**Turtle Creek No. 3 Primary Pump Station Project**  
**Solicitation Number: CO-00404-SM**  
**Job No.: 21-6001**

**ADDENDUM NO. 4**  
**September 21, 2021**

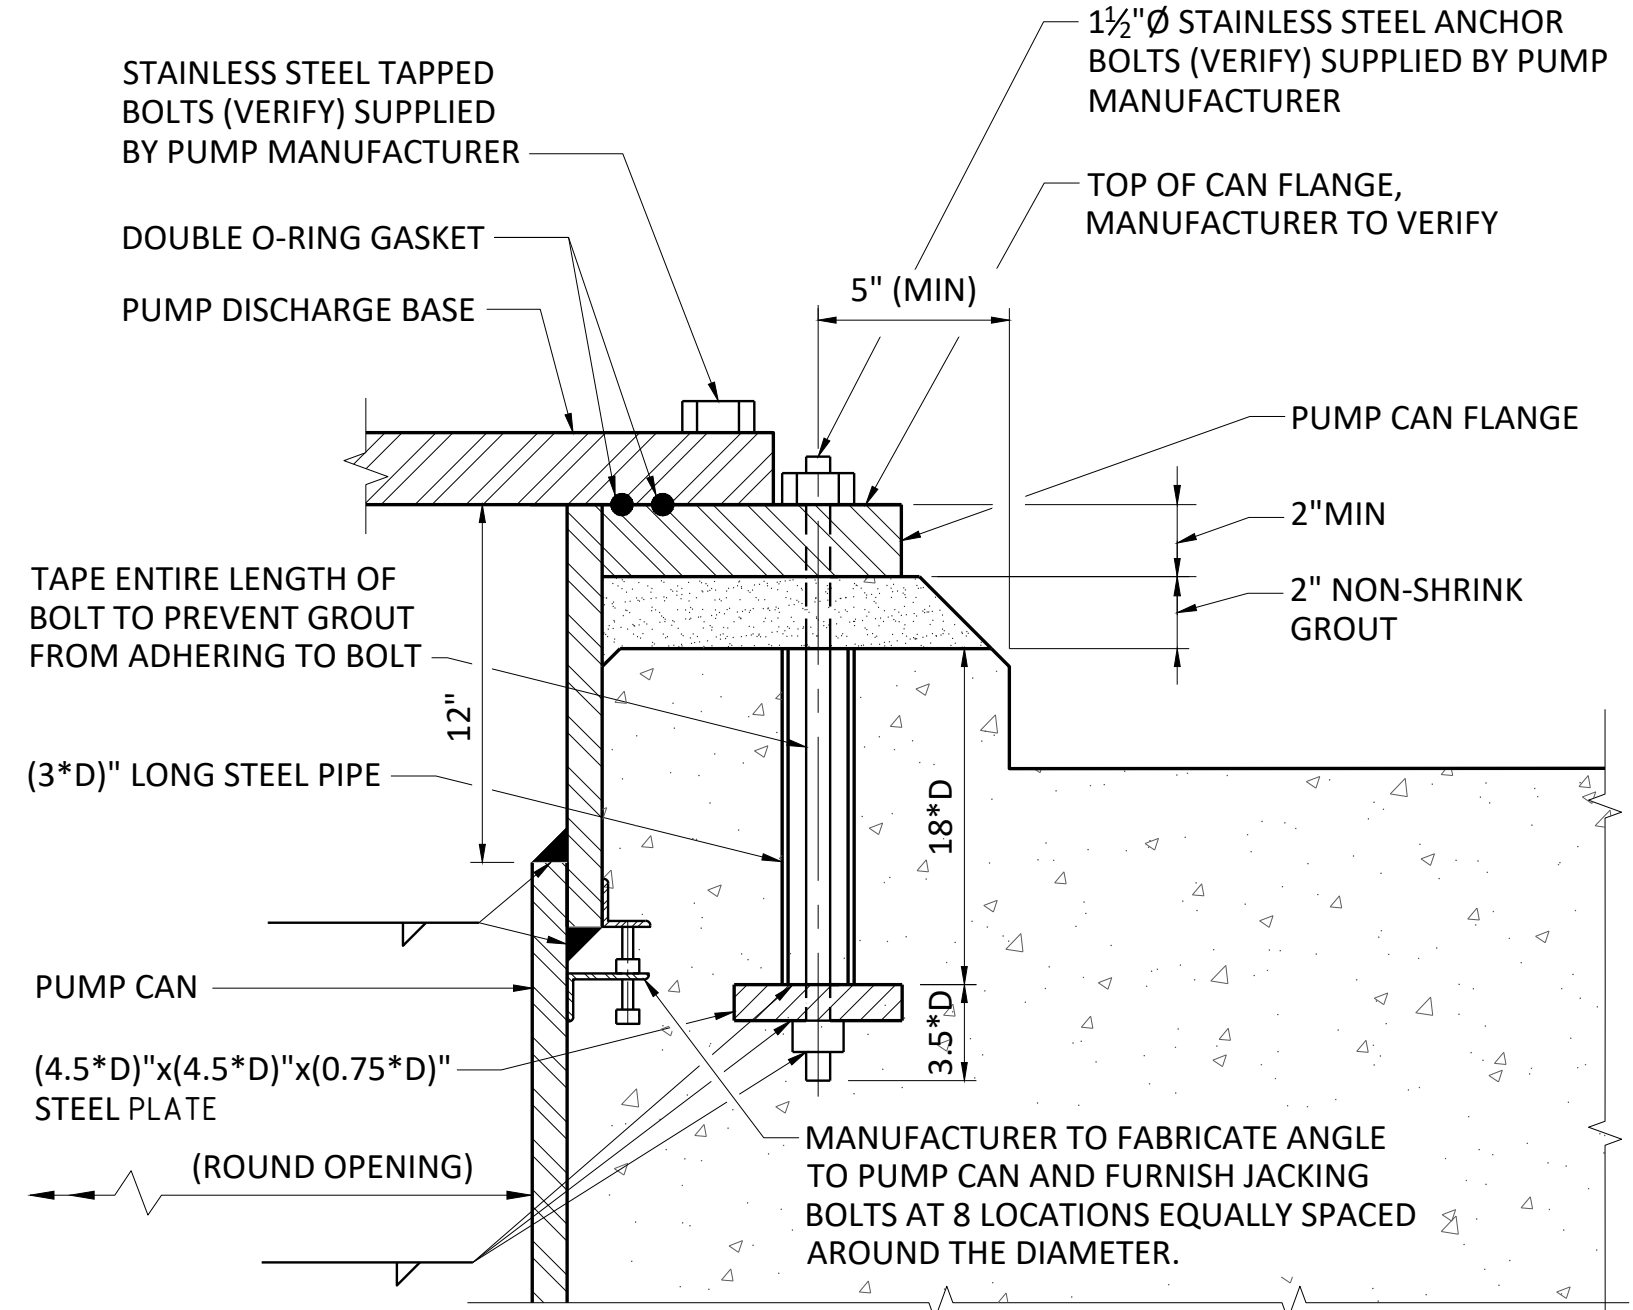
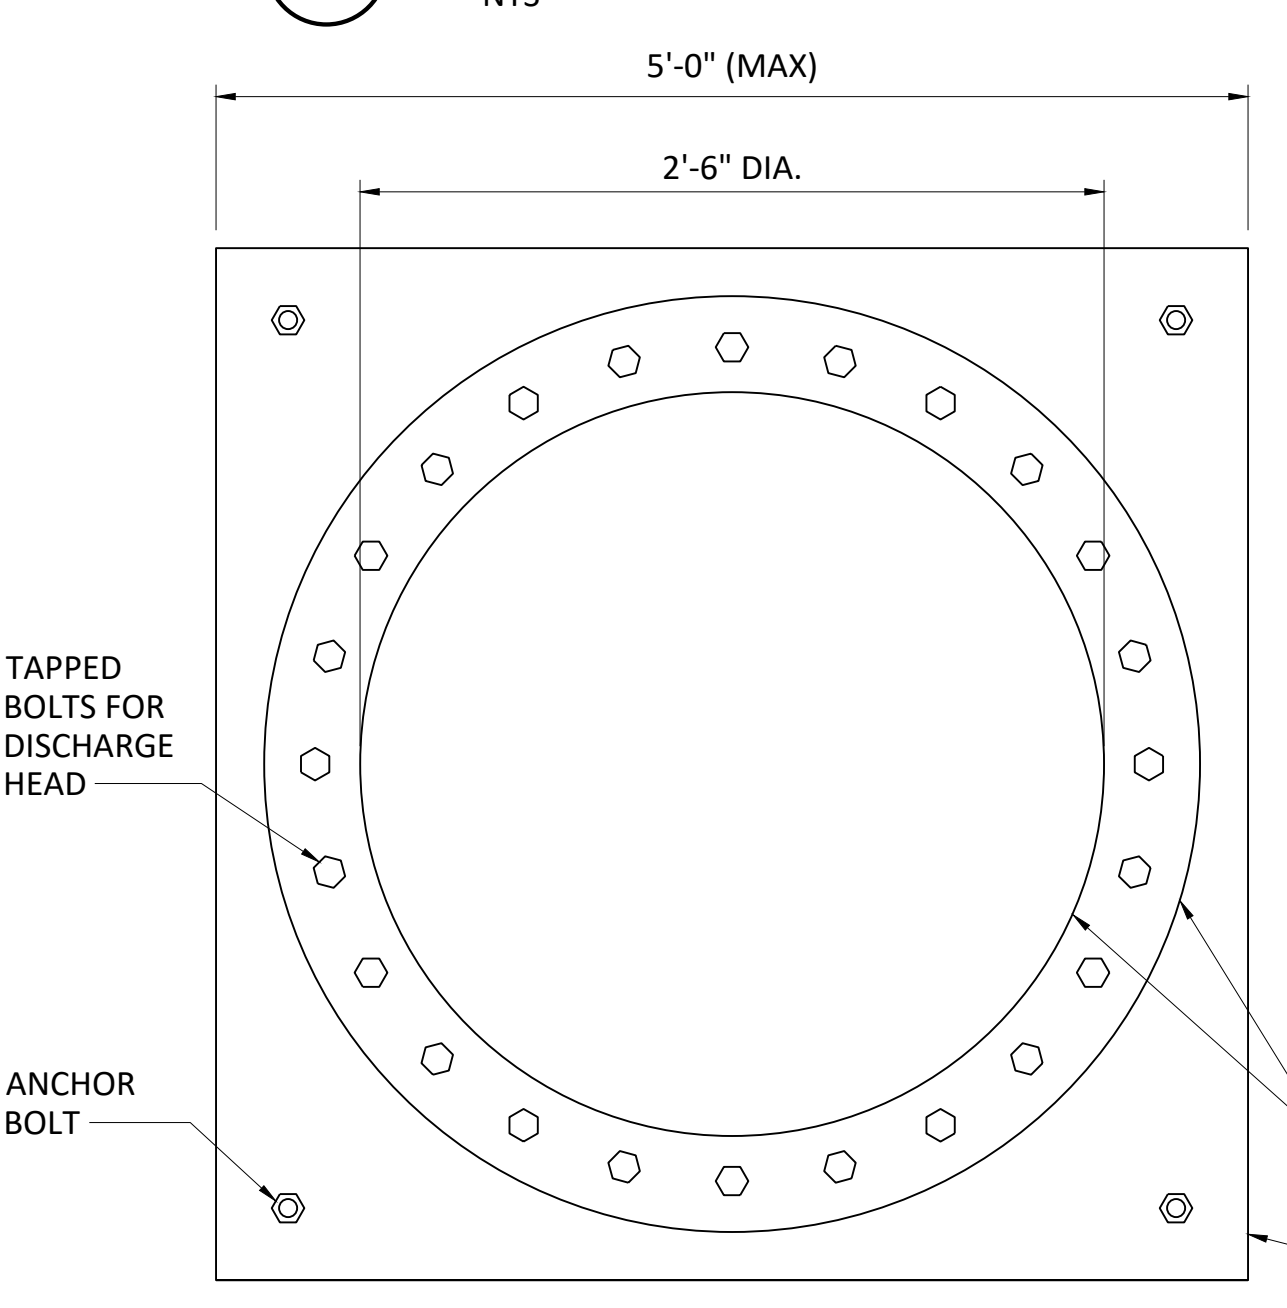
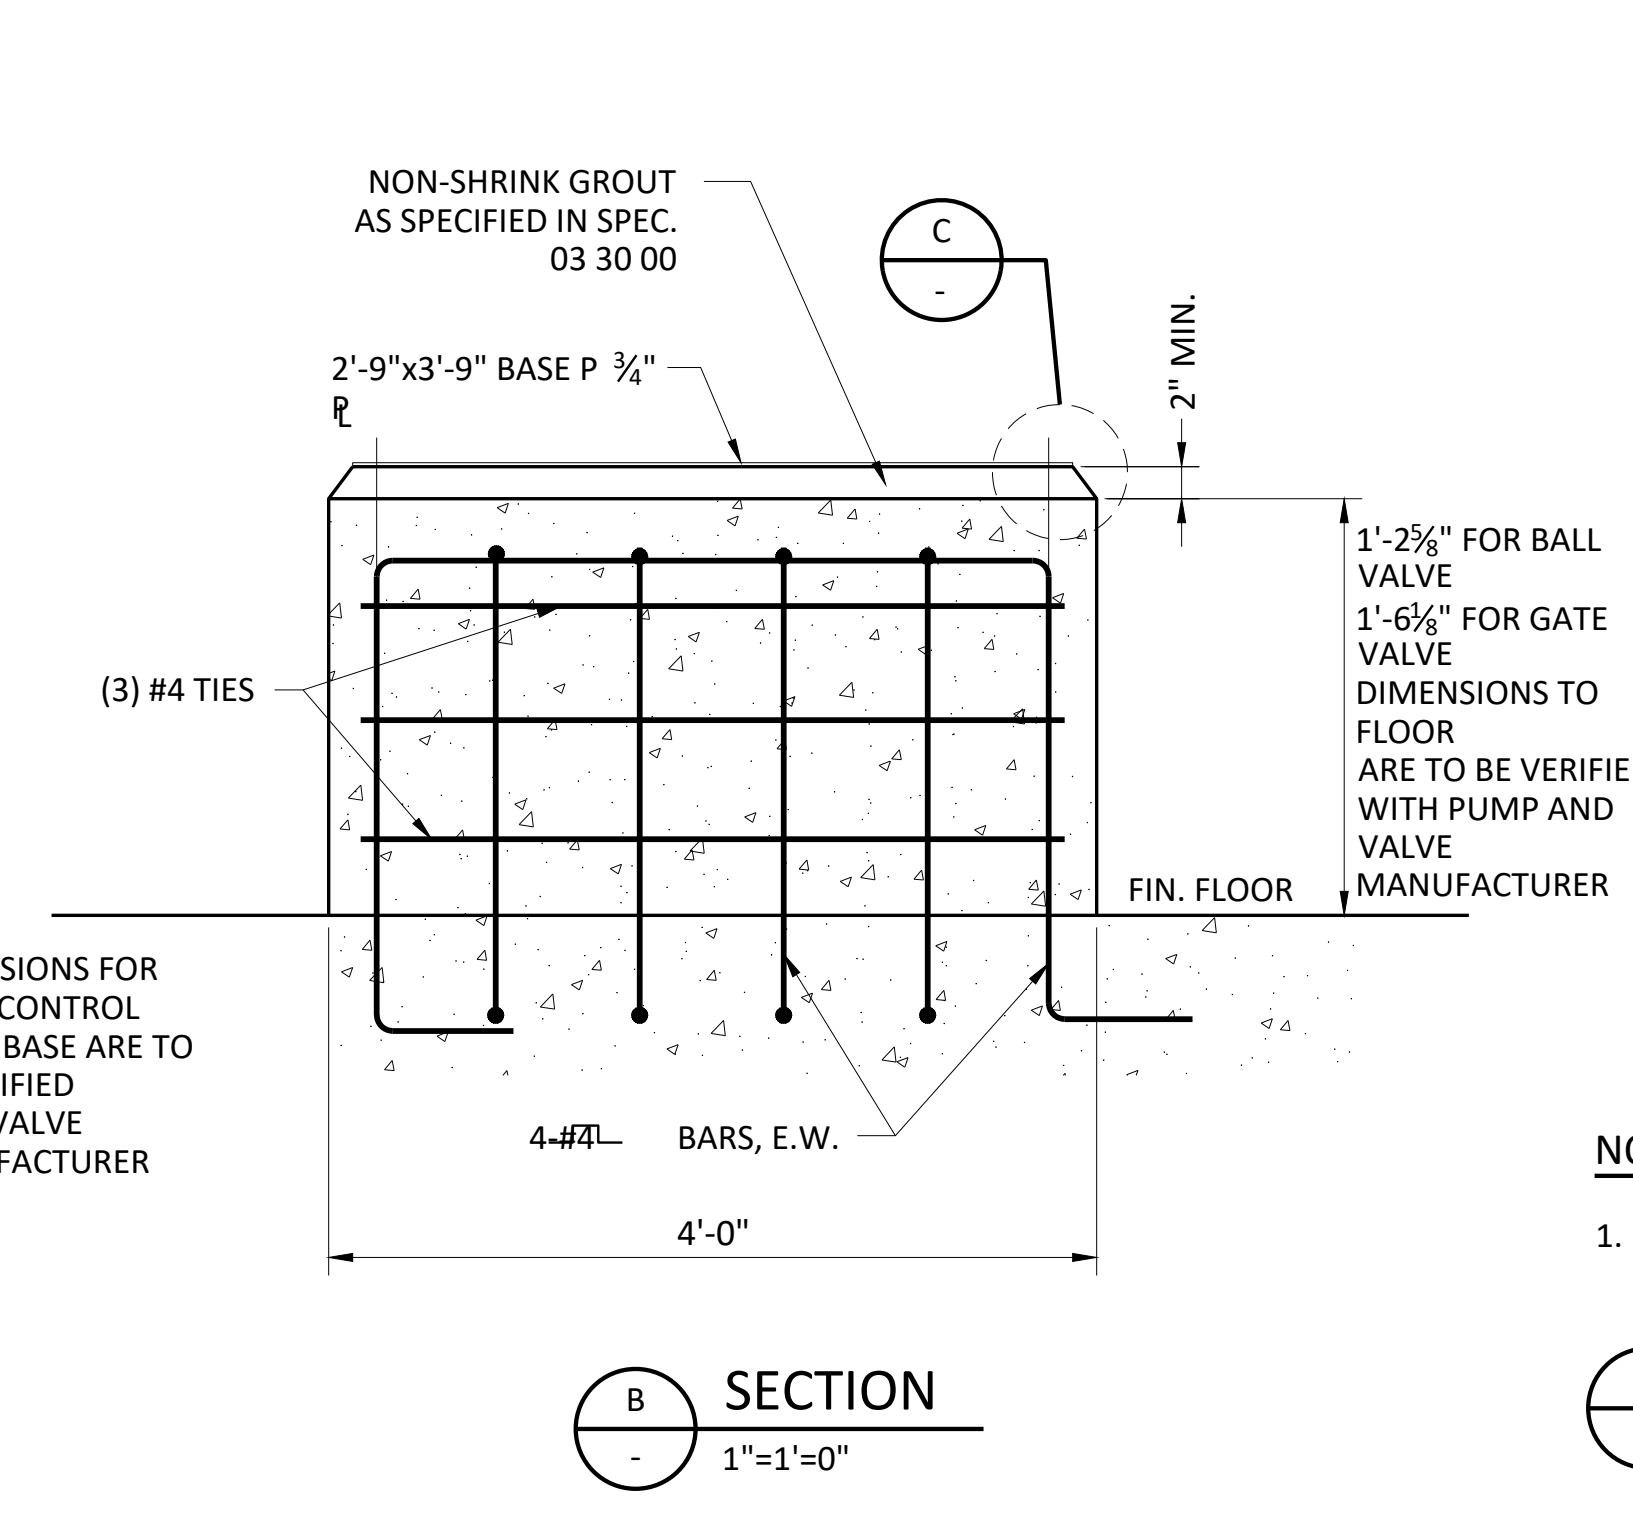
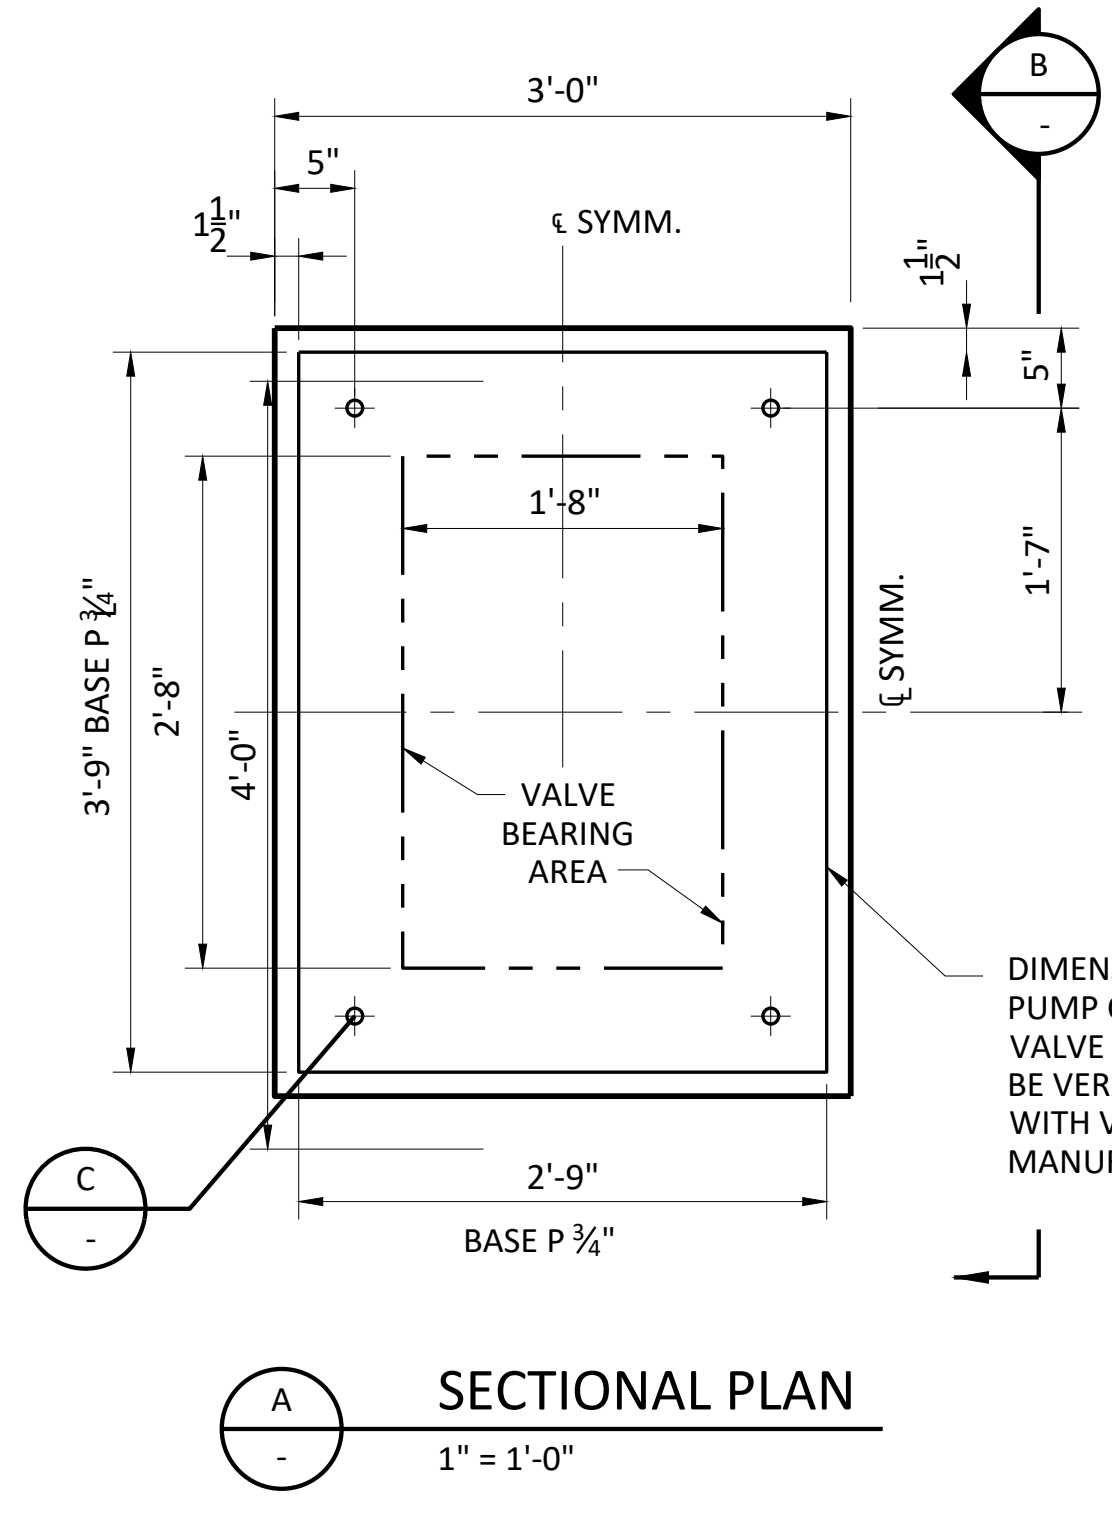
5. **Question: Section 44 42 56.02 1.01.B – Remove reference to sole plate. Pumps installed in barrels with integral top flange. Remove lower floor column brace.**

1. **Delete** Drawing G-5 in its entirety **and replace with** revised Drawing G-5 included in this addendum.
2. **Delete** Drawing SD-5 in its entirety **and replace with** revised Drawing SD-5 included in this addendum.
3. **Delete** Drawing SD-6 in its entirety **and replace with** revised Drawing SD-6 included in this addendum.
4. **Delete** Drawing S-1 in its entirety **and replace with** revised Drawing S-1 included in this addendum.
5. **Delete** Drawing E-4 in its entirety **and replace with** revised Drawing E-4 included in this addendum.
6. **Delete** Drawing E-8 in its entirety **and replace with** revised Drawing E-8 included in this addendum.
7. **Delete** Drawing EB-7 in its entirety **and replace with** revised Drawing EB-7 included in this addendum.
8. **Drawing T-4, Note 2:**

*Response: Section 44 42 56.02, Paragraph 1.01.B's reference to sole plate shall remain. Pumps may utilize an integral top flange however the flange must connect to the sole plate per the details shown on Drawing SD-5. References to lower floor column brace have been removed. Refer to Item No. 20 in CHANGES TO THE SPECIFICATIONS section of this addendum.*
